Technical Service Bulletin: TSB170047

Aftertreatment System Alignment Arrows Misaligned on Firetruck Applications

Figure 1, Alignment Arrows.

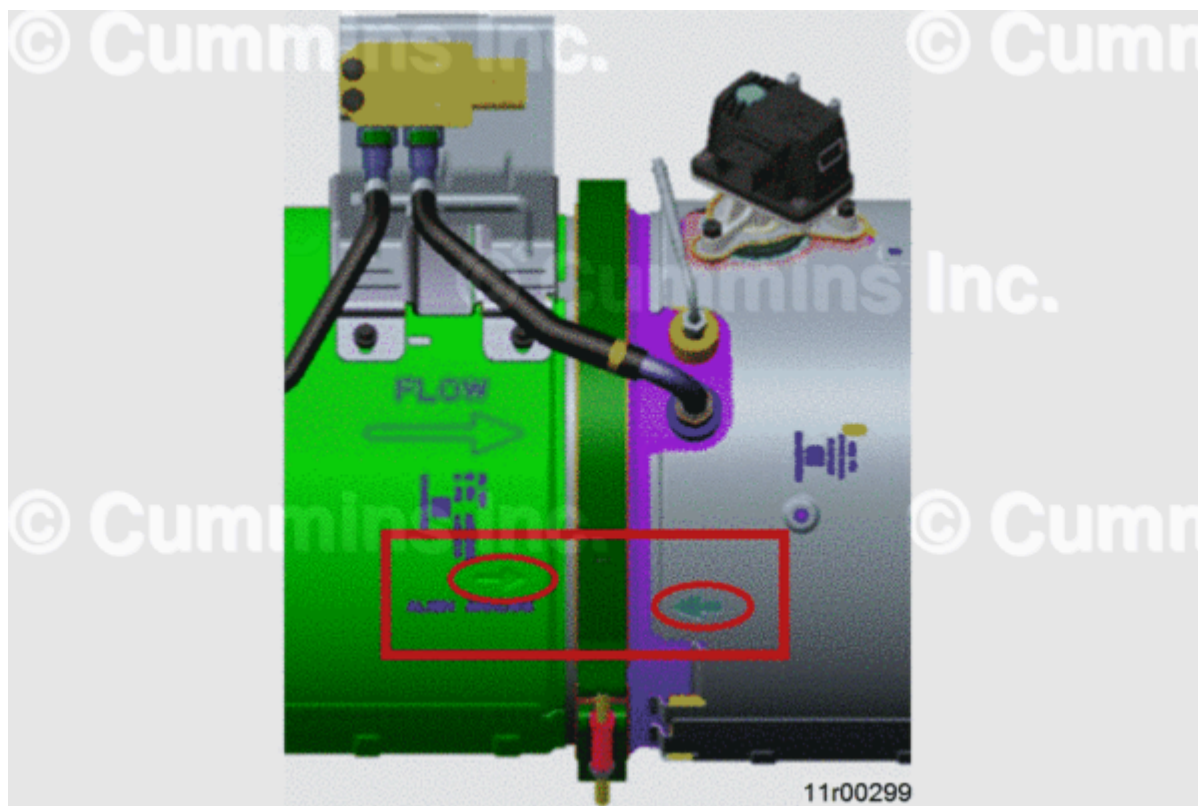
Alignment arrows on aftertreatment diesel particulate filter (DPF) and aftertreatment decomposition tube are intentionally misaligned by approximately 10 degrees. See Figure 1 below.

If aftertreatment DPF and aftertreatment decomposition tube alignment arrows are in alignment, differential pressure sensor tube connected to aftertreatment decomposition tube will not fit properly and can become kinked and/or bent.

- Misalignment of aftertreatment DPF and aftertreatment decomposition tube is required to allow for adequate aftertreatment system clearance in this application.
- Prior to loosening or removal of aftertreatment v-band clamp, aftertreatment DPF, or aftertreatment decomposition tube; an orientation reference line **must** be drawn across aftertreatment DPF, v-band clamp, and decomposition tube to aid in assembly.
- Use orientation reference lines added prior to loosening or removal to assist in correct differential pressure sensor tube alignment during assembly.
